ADDENDUM NO. 1

Gravesite Restoration at East Hawaii Veterans Cemetery No. 2, Hilo, Hawaii
State of Hawaii, Department of Defense, Office of Veterans Services
Job No. CA-202617-C, FAI No. HI-10-29

CS501

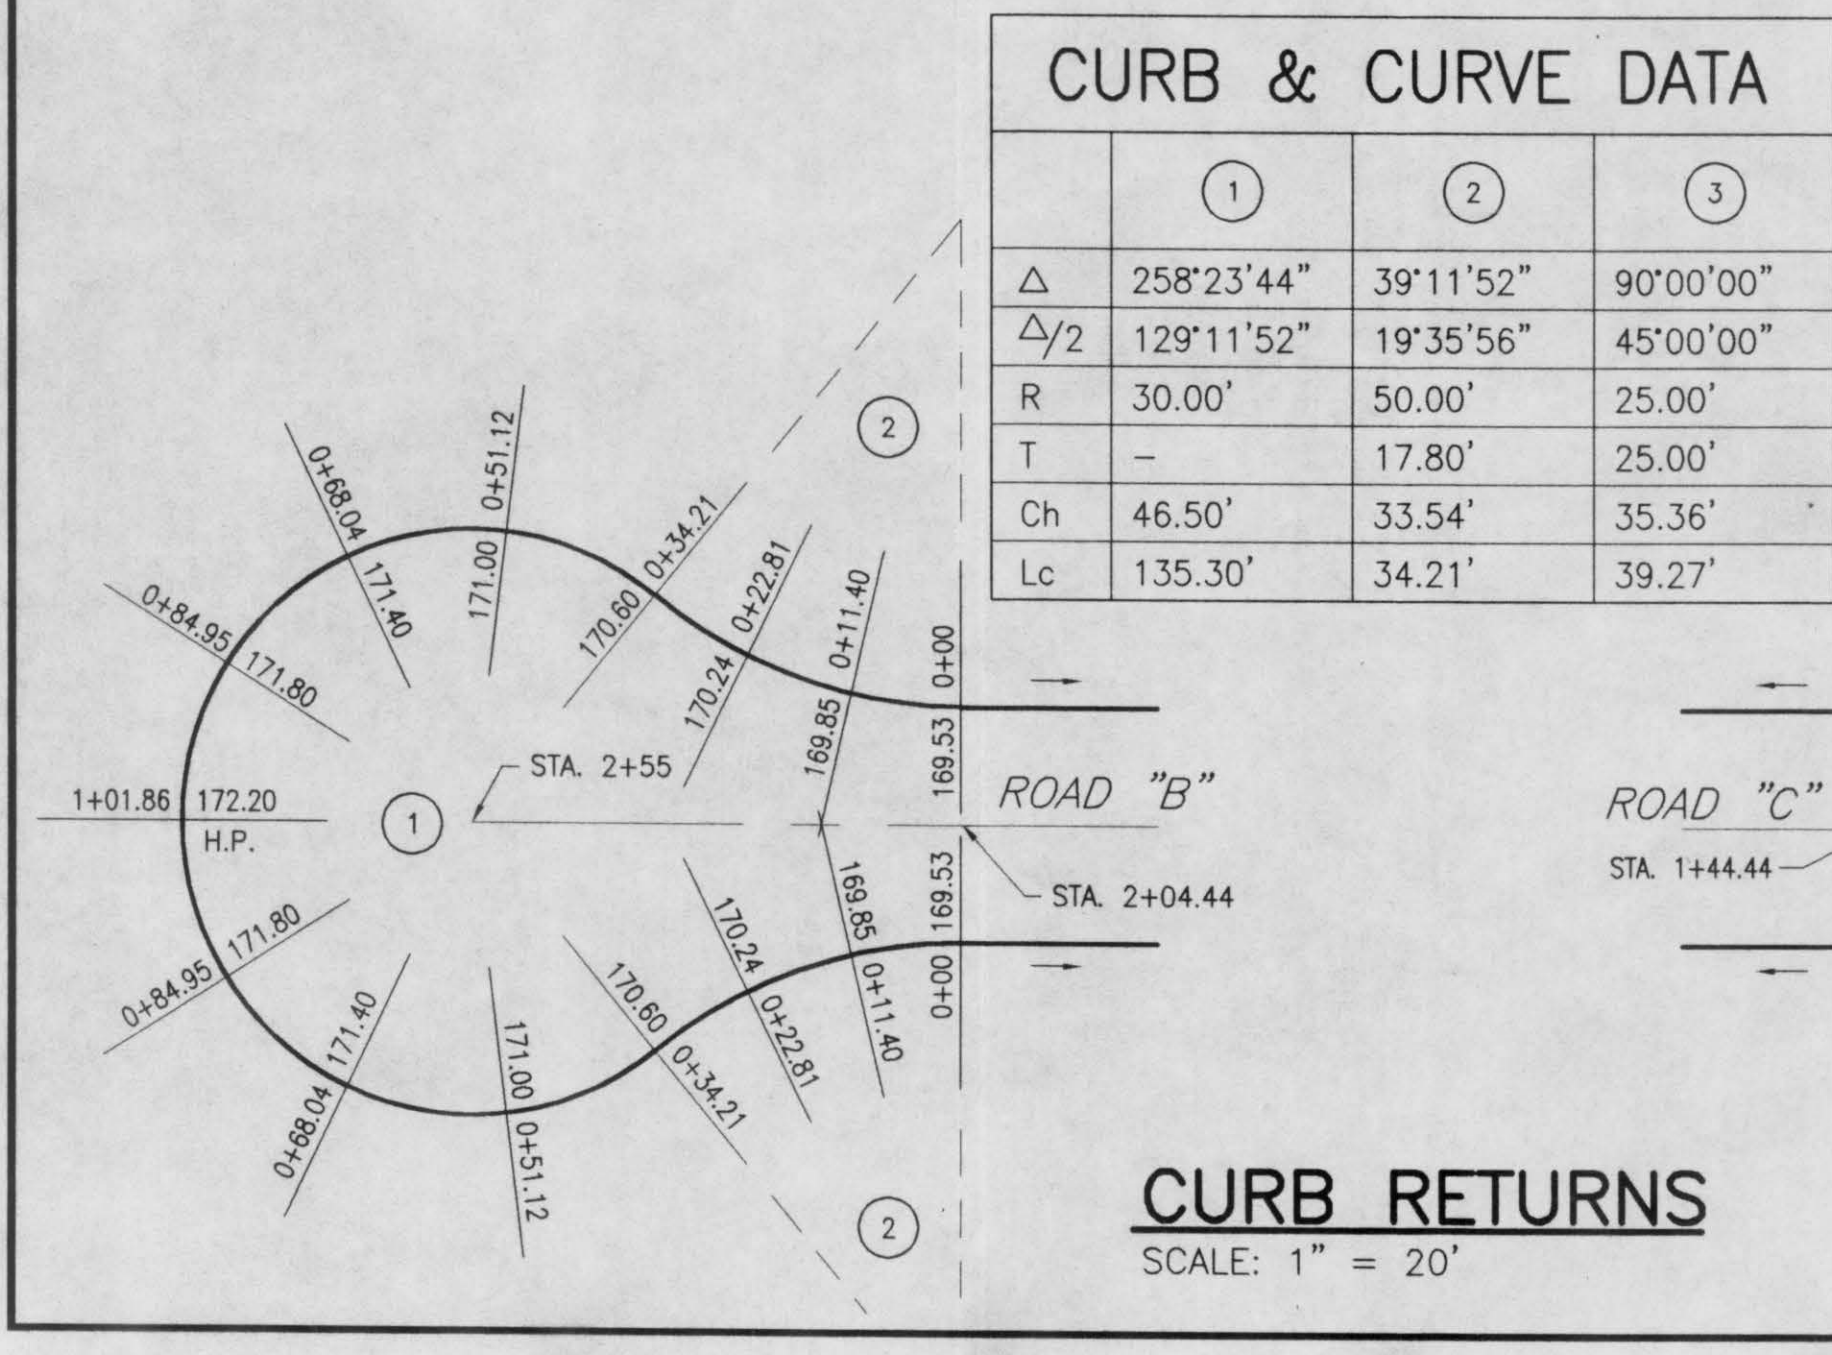
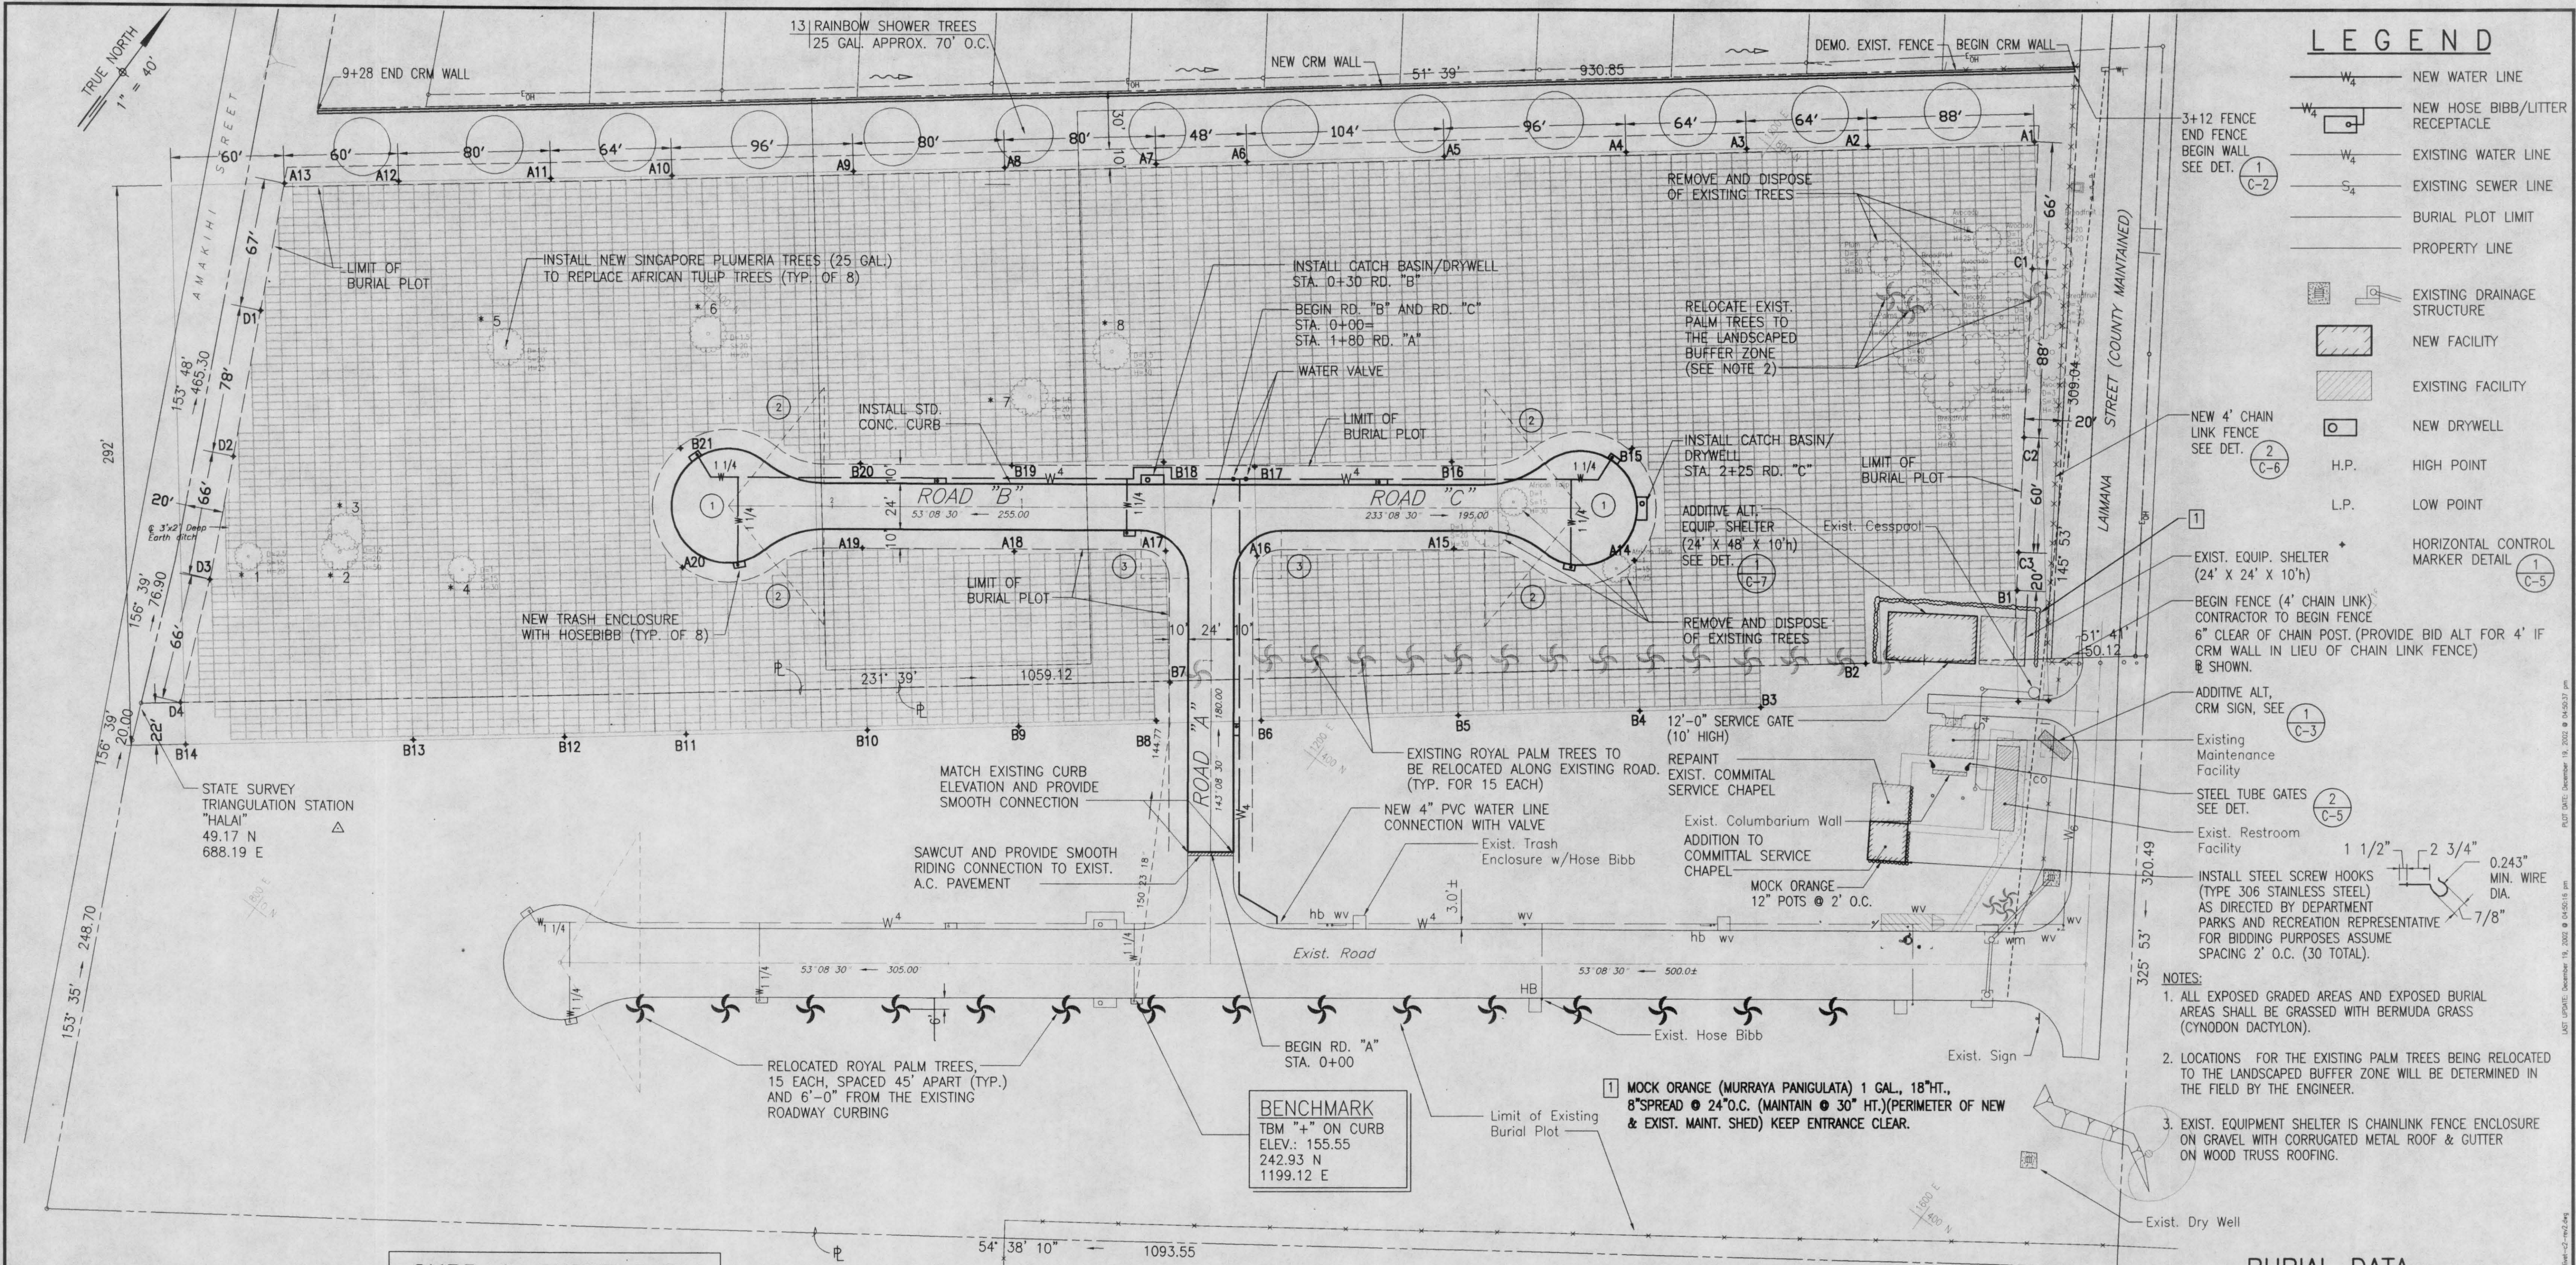
Response: Reinforcement should be included using 6 x 6 – W.14 x W1.4 WWF reinforcement.
3. Plan sheet CS501 detail B2 and C1 shows 3” of topsoil, landscape plans call for 4” of topsoil, 1” being the amended topsoil. Please clarify if the topsoil is 3” topsoil + 1” amended soil for a total of 4” of topsoil or total 3” that includes the 1” of amended soil.

1. CS501 – Details B2 and C1, revise:
Detail revised to show 4" topsoil.

Response: The 4” imported topsoil depth represents the depth of the new soil relative to the finished grade, including the 1” layer of soil amendment. The typical sequence is placement of the 4” layer of topsoil, then adding 1” layer of soil amendment (well-aged compost) and incorporating into the topsoil by tilling and fine grading so that the 1” layer of soil amendment becomes a part of the 4” total topsoil depth.
